Purpose - Householder planning application

All dimensions to be checked on site. All omissions & discrepancies to be reported to the designer.	PROJECT: 44 Raisins Hill, Pinner, HA5 2BS	DATE: 21/03/2022
	DWG. TITLE: GROUND FLOOR	REVISION: 09 A

PROPOSED

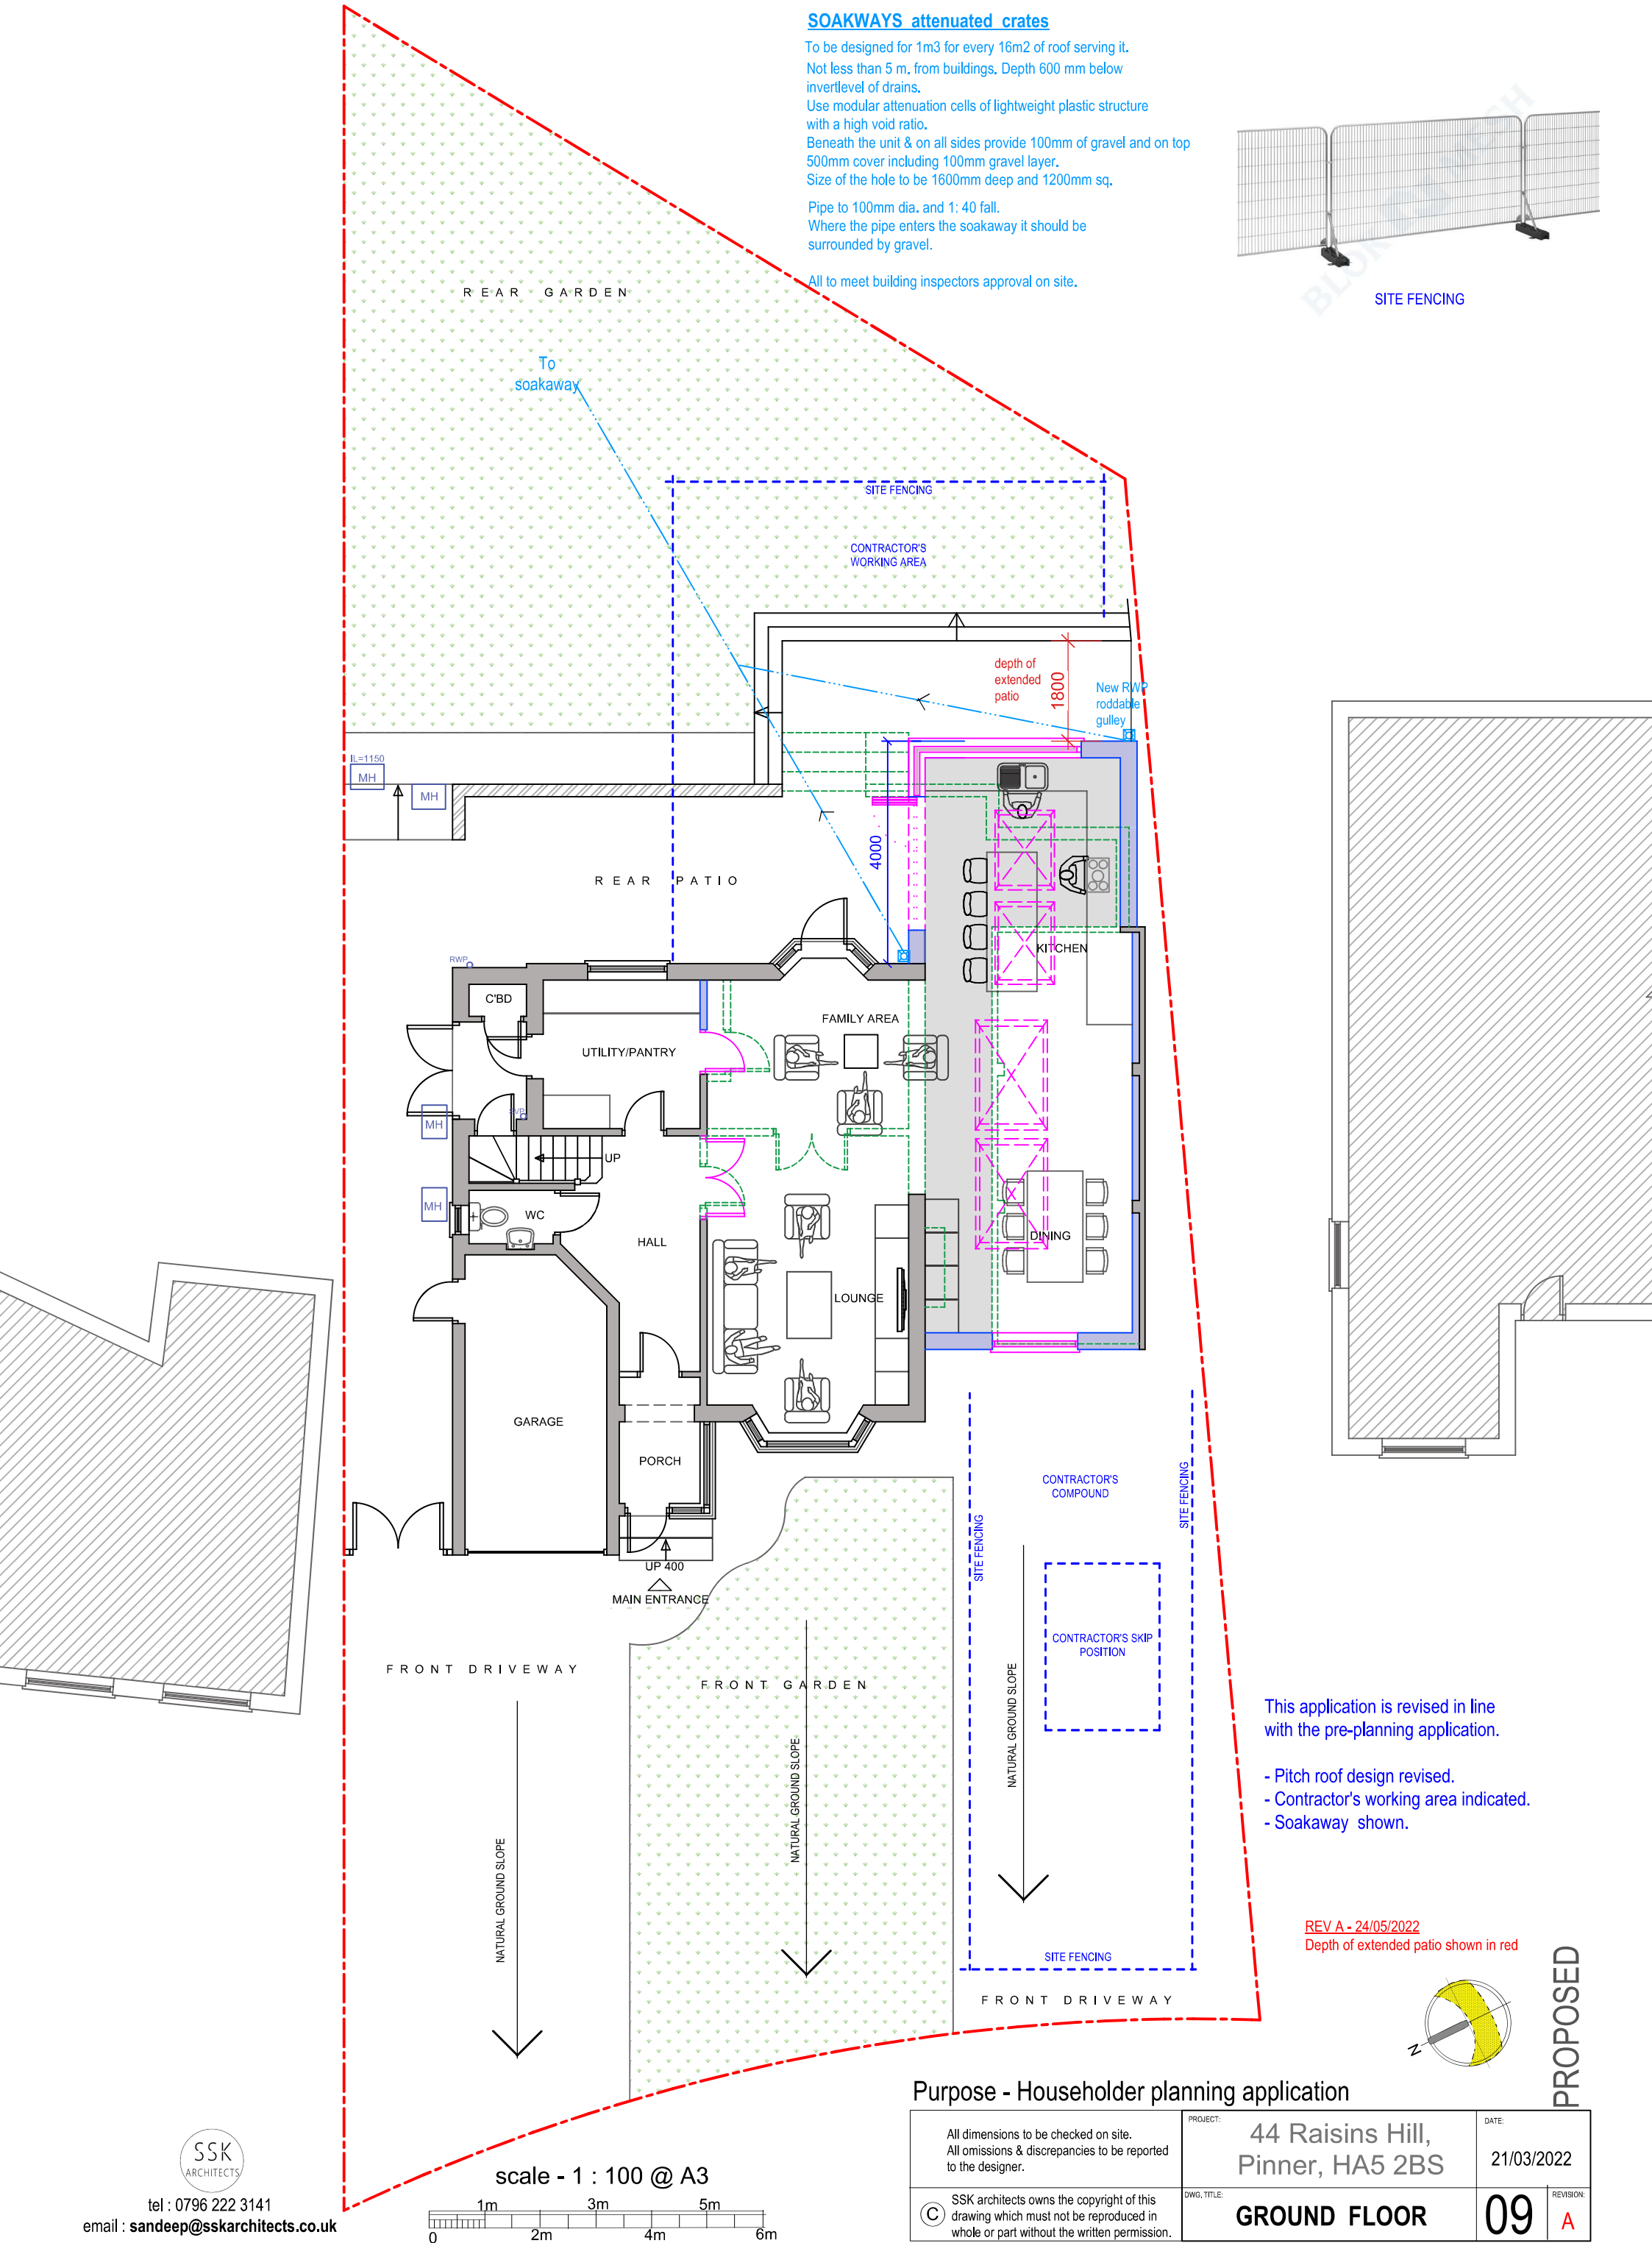
This application is revised in line with the pre-planning application.

- Pitch roof design revised.
- Contractor's working area indicated.
- Soakaway shown.

REV A - 24/05/2022
Depth of extended patio shown in red
